PLANNING BOARD AGENDA

DATE: Tuesday, December 13, 2022
TIME: 6:00 P.M.

PB22-9: 771 & 787 Main St. (Map 6, Lots 43, 44, & 154) – Clover Farm Subdivision (8 lots) – Preliminary Plan

To: Planning Board
 From: Jeff Brubaker, AICP, Town Planner
 Cc: Ken Wood, PE, Attar Engineering, Applicant's Representative
 Mike Sudak, EI, Attar Engineering, Applicant's Representative
 Shelly Bishop, Code Enforcement Officer
 Date: December 10, 2022 (report date)
 December 13, 2022 (meeting date)
 Re: PB22-9: 771 & 787 Main St. (Map 6, Lots 43, 44, & 154) – Clover Farm Subdivision (8 lots) – Preliminary Plan

SCALE: 1" = 50'	APPROVED BY: MJS	DRAWN BY: MJS
DATE: 04/12/22	REVISION DATE: G : 12/06/22	
JOB NO: C174-21	FILE: MAIN ST REV BASE.DWG	SHEET: 1

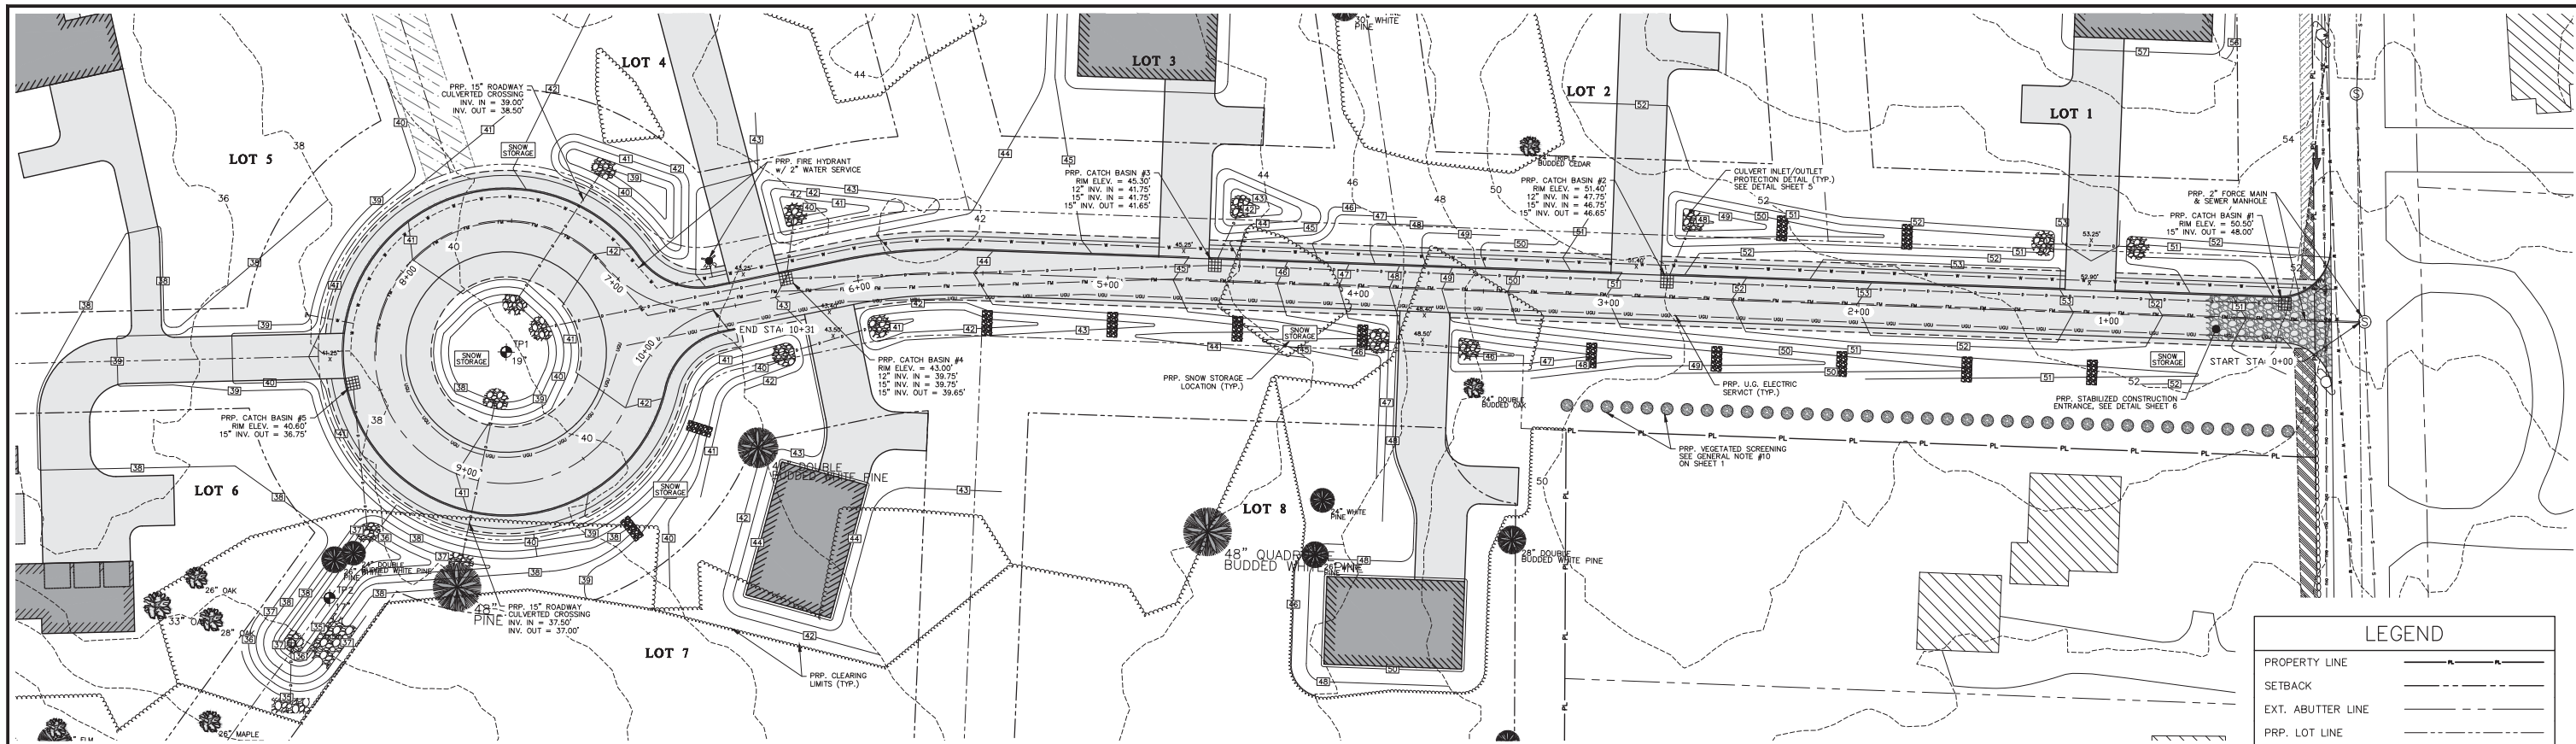
Max. non-vegetated footprint in shoreland zone: 20%	Appears to be met. See Sheet 1, Note 8. Non-vegetated footprint is calculated at 14.6%.

Min. cul-de-sac pavement width around the center island: 25 ft.	Met. Sheet 1 shows 25 ft.
Sight distance	Appears to be met. Sight distance triangles added to plans.

Remick Cemetery access, as previously discussed, continues to be provided for on Sheet 1 (between Lots 4-5) and described in Note 13.

3. Sheet 1 has been revised as requested to be titled “Preliminary Subdivision Plan” and shall be stamped by Maine-licensed Professional Land Surveyor.

16. Sheet 1 (Preliminary Subdivision Plan) has been updated to include an additional stormwater drainage easement along the travelway frontage of Lots 1 & 2 to encompass the roadside swale and culverted crossing not located within the right-of-way of the proposed Minor Road.
17. Sheet 1 has been updated to include metes and bounds descriptions for all proposed stormwater easements. General Note #18 on Sheet 1 has been added to denote the type of permanent monumentation that shall be installed to delineate these stormwater easement limits.
18. Language has been added to the 'Swales' portion of the Road and Stormwater Maintenance Program which includes the retention of flowage rights by the association for surface runoff through the existing natural swale across Lot #6 towards the Piscataqua River.

ROADWAY PLAN & PROFILE
CLOVER FARM SUBDIVISION
MAIN STREET, ELIOT, MAINE

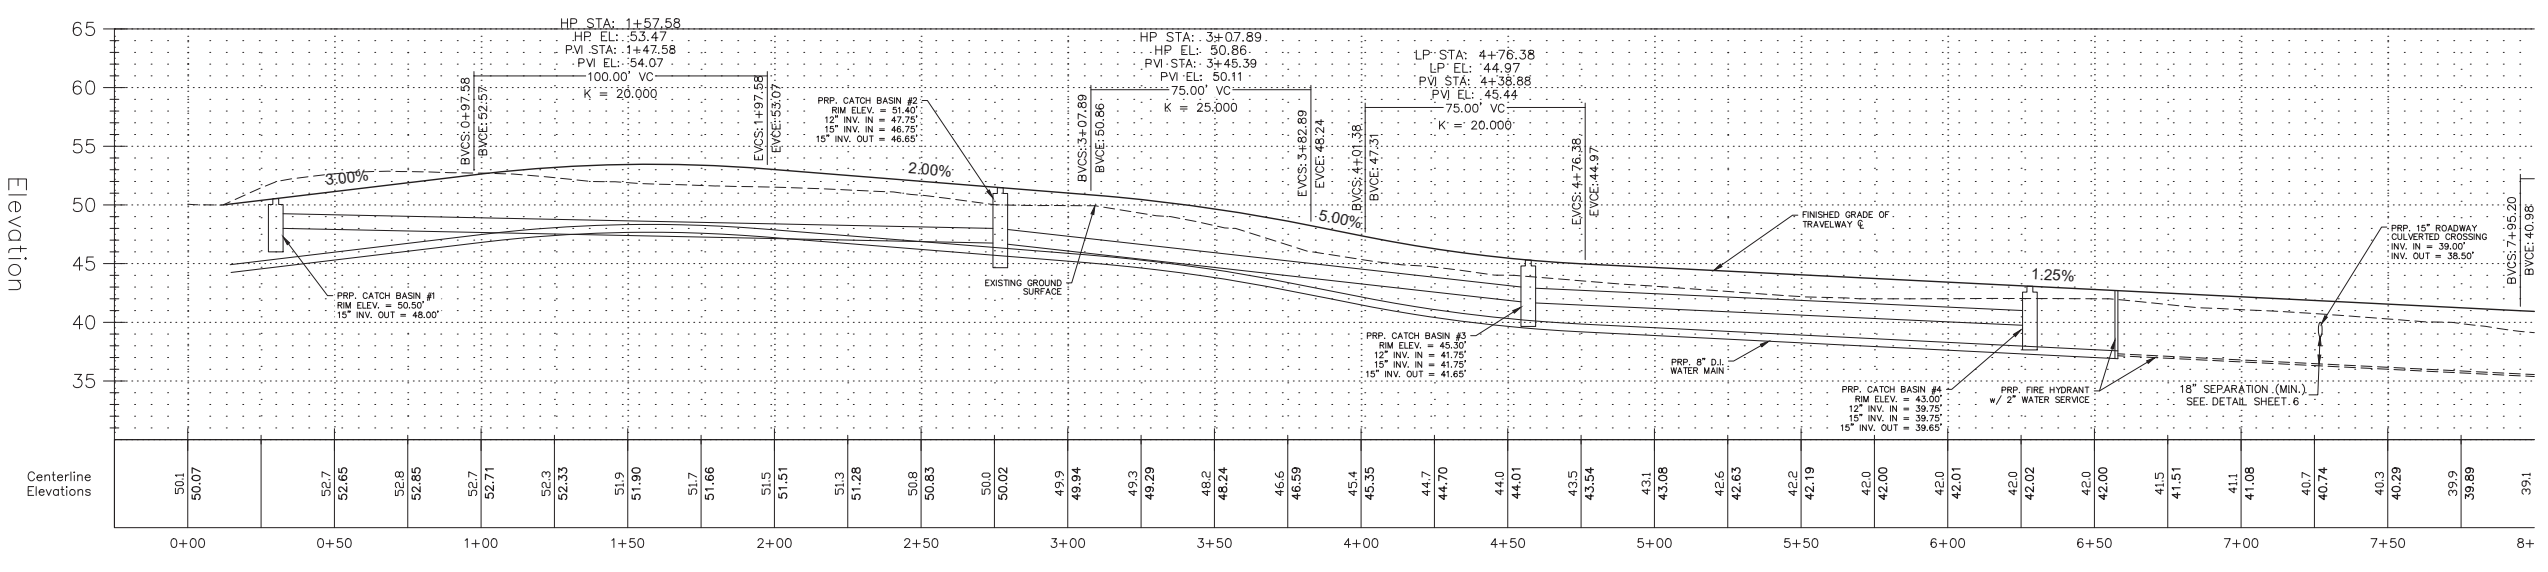
Min. grade: 0.5%	Met. Grade is 1.25% to 5% as shown in the roadway profile on Sheet 4.
Max. grade: 8.0%	Met. See above.
Max. grade at intersections: 3%	Appears to be met. Grade appears to be 3% at Main St. intersection.
Min. angle of street intersections: 75 degrees	Visually appears to be met
Min. centerline radius of curves: 100 ft.	Appears to be met. Road is mostly straight with slight curve of radius >175 ft. (Sheet 1).
Min. tangent length b/t reverse curves: 100 ft.	Visually appears to be met
Roadway crown: 1/4" per ft. of lane width	Met. See detail on Sheet 6.
Min. curb radius at 90-degree intersections: 20 ft.	Appears to be met with 10/18/22 submittal
Min. right-of-way radii at intersections: 10 ft.	Appears to be met with 10/18/22 submittal
Cul-de-sac concentric radii: 30'/40'/65'/70'	Met. See Sheet 1. R/W radius around cul-de-sac increased to 75 ft. to accommodate the sidewalk.
Cul-de-sac suitable snow storage	Met. See Sheet 3.

The underground utility line is shown under the southeast half of the road. See Sheet 4 and trench/conduit detail on Sheet 6. The PB did not require 10% open space reservation per 41-220(c).

SCALE: 1" = 40' APPROVED BY: MJS DRAWN BY: MJS
DATE: 08/23/22 REVISION DATE: C : 12/06/22
JOB NO: C174-21 FILE: MAIN ST REV BASE.DWG SHEET: 5

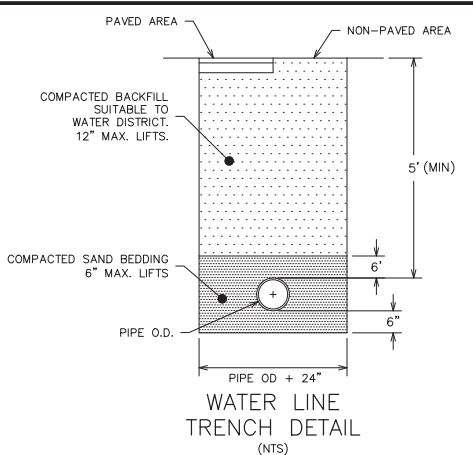
Erosion & sedimentation control notes are on Sheet 5, as required by 41-150(10) and 41-214(c). For the E&SC standards check, see the attachment at the end of this report.

The application is subject to the Erosion and Sedimentation Control ordinance amendments (primarily new Ch. 34) enacted by voters on November 8. Sheet 5 has been updated accordingly. The motion template includes a recommended motion to approve the E&SC plan.

Outside of the Third Party Review comments, the Applicant has also revised Sheet 5 of the Plan Set to include language presented in the newly-adopted Chapter 34: Erosion and Sedimentation Control. The bulk of these revisions is reflected in Sheet 5, where the Erosion & Sedimentation Control Notes packages have all been updated to reflect Chapter 34's Appendix 1. The Applicant feels that these changes, in combination with the content already provided within the Grading & Utilities Plan, Stormwater Narrative, and Road and Stormwater Maintenance Program document, satisfy §34-4 "Submission Requirements".

ROAD CROSS SECTION
(SIDEWALK ONE SIDE - ADJACENT TO ROAD)

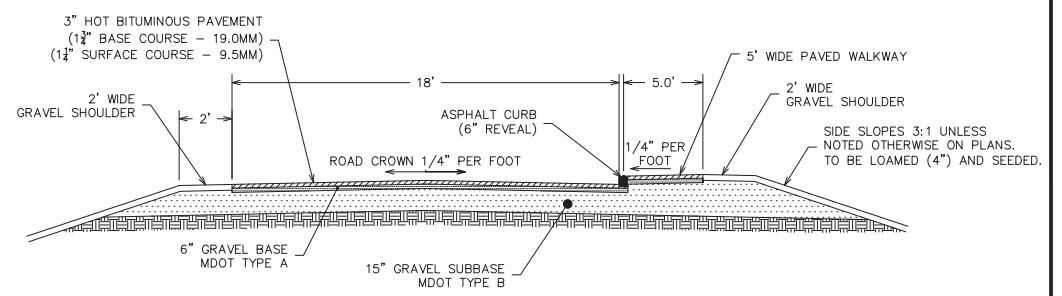
8. The Road Cross Section Detail on Sheet 6 has been updated to provide additional information on pavement specifications aligned with MDOT standards as requested.

EMERGENCY SPILLWAY DETAIL
(NTS)

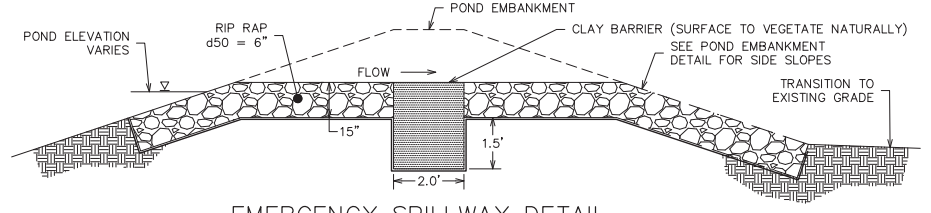
12. Drainage Plan-related additional comments:
 - The Emergency Spillway Detail on Sheet 6 has been revised to include the depth and rip rap d50 size as requested. The associated callout on Sheet 3 has also been revised as requested.

SCALE: 1" = 50'	APPROVED BY: MJS	DRAWN BY: MJS
DATE: 08/23/22	REVISION DATE: A : 12/06/22	
JOB NO: C174-21	FILE: MAIN ST REV BASE.DWG	SHEET: 7

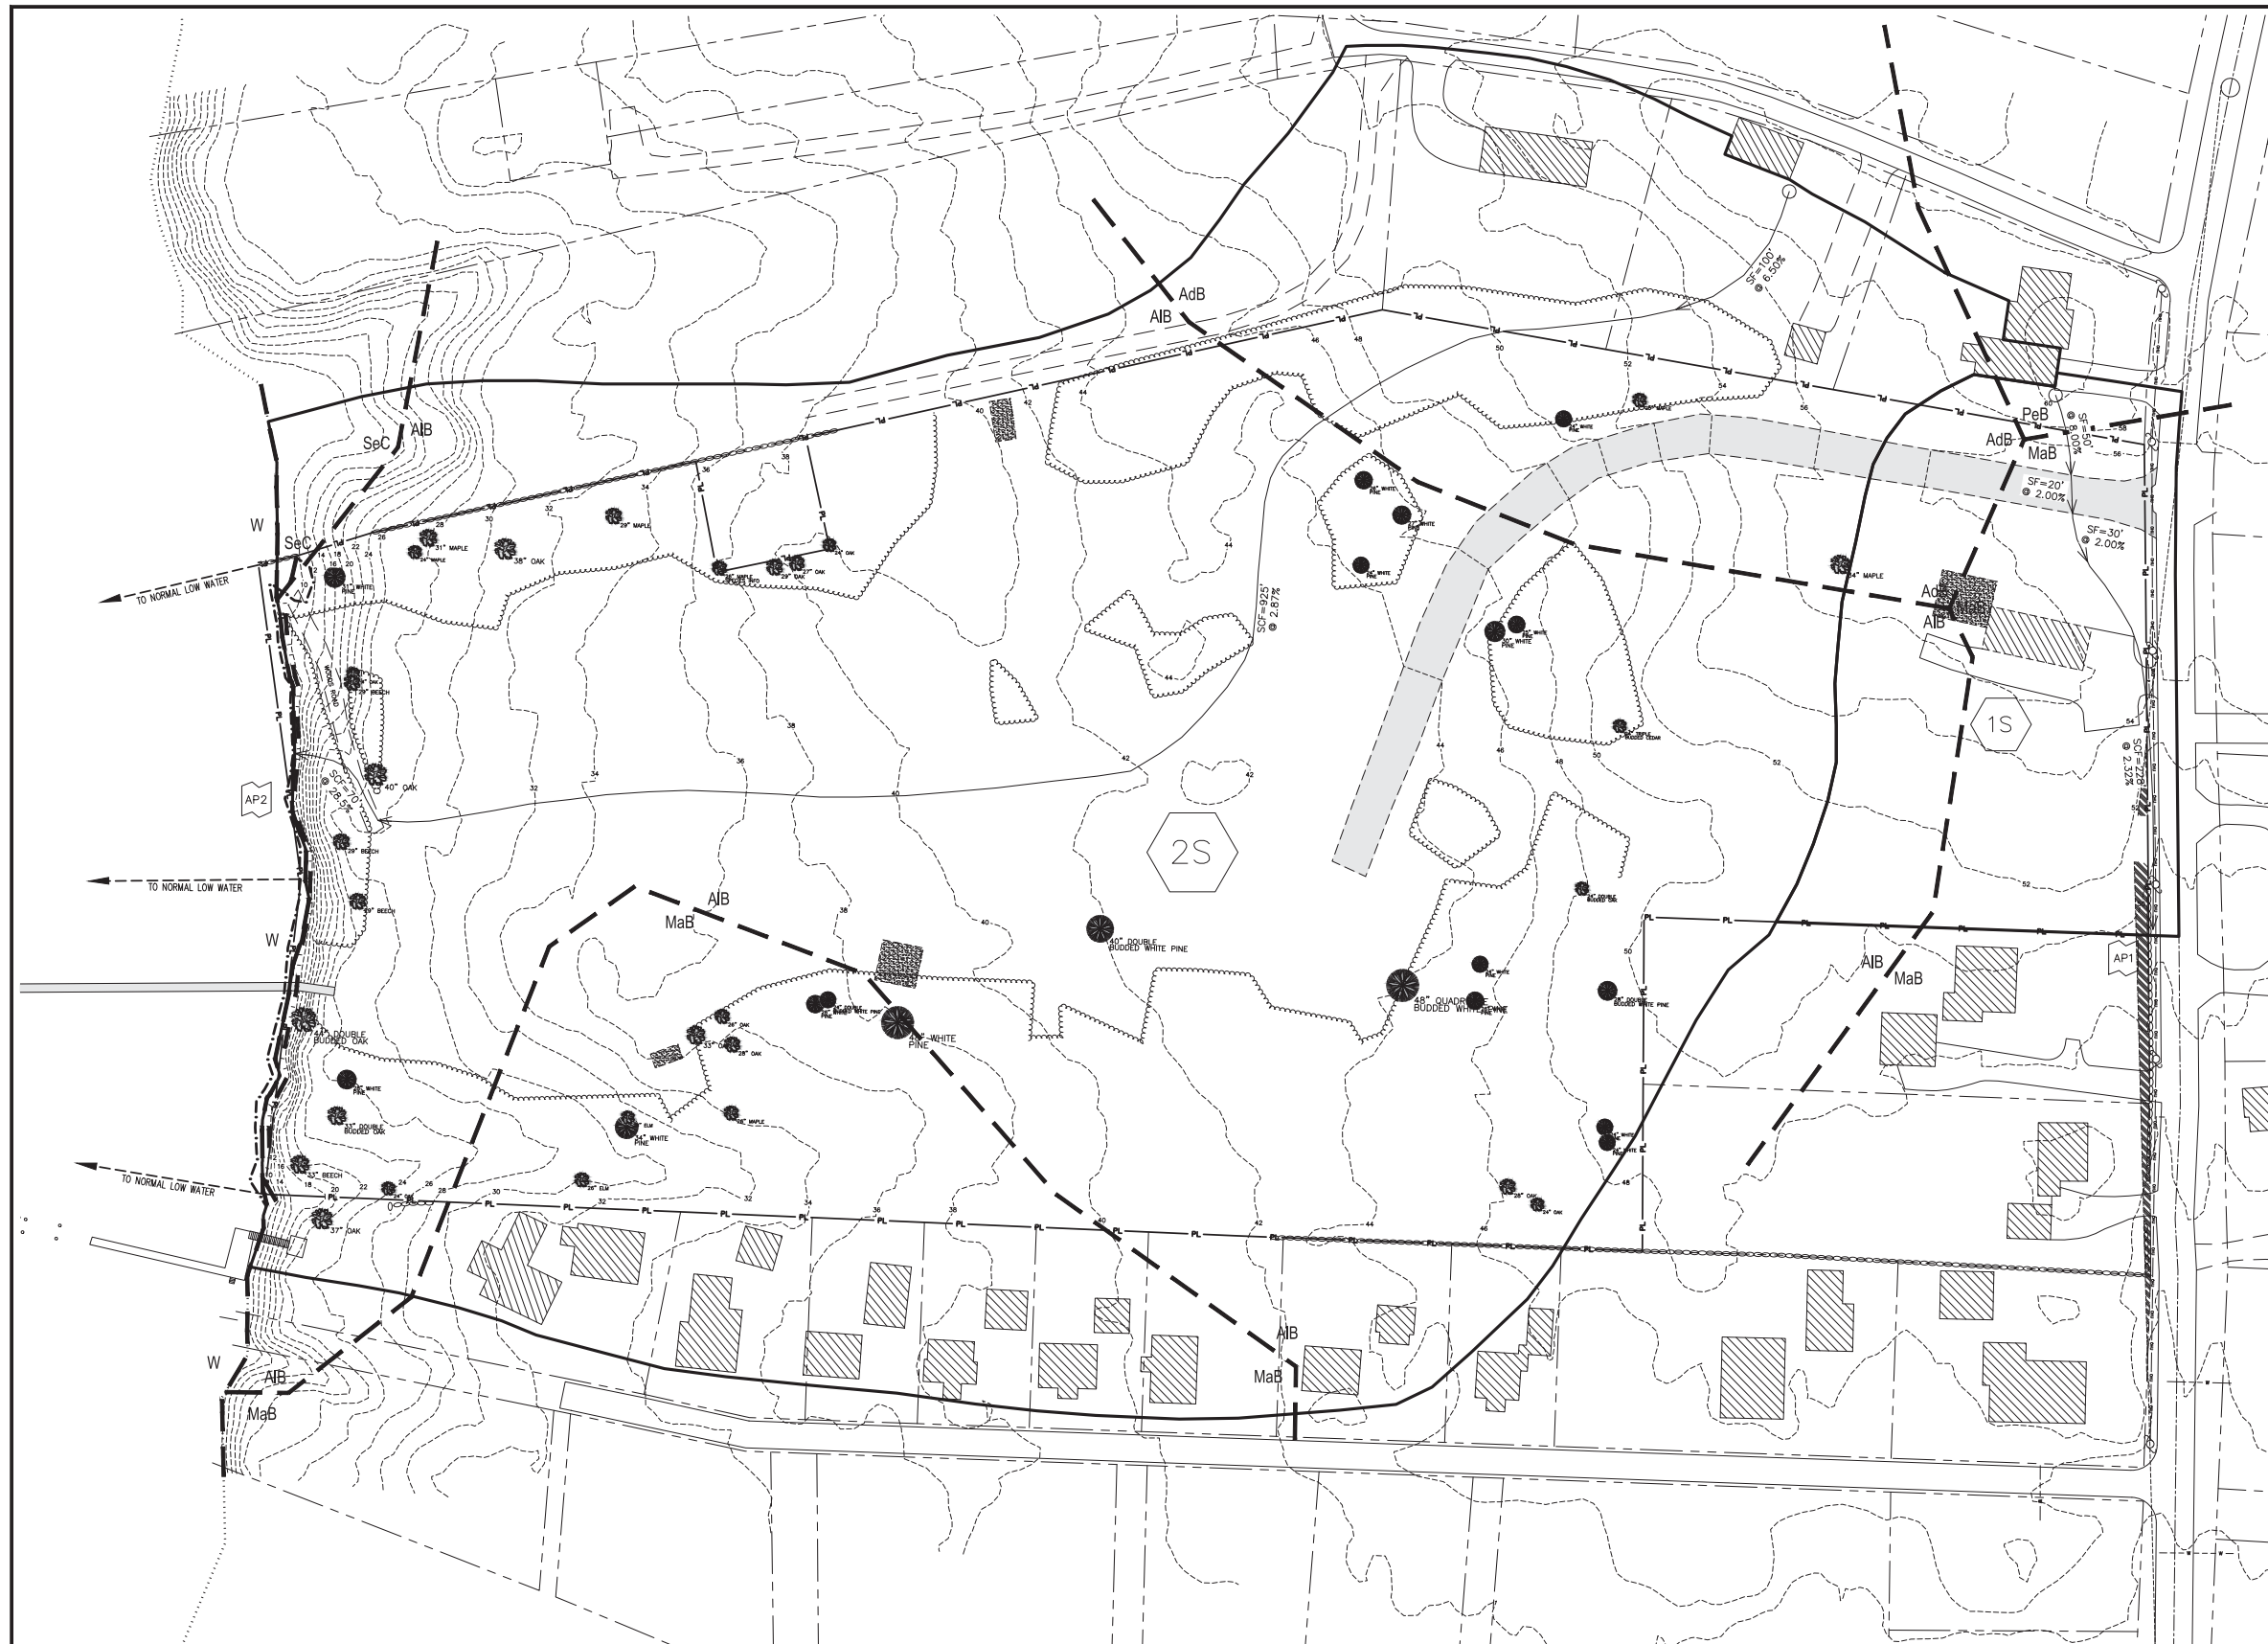
Note the two new test pit results from Michael Cuomo, in your packet. Both test pits found Nicholville soils that are soil group D, moderately well drained. Test pit locations are shown on current site plan sheets 7-8.
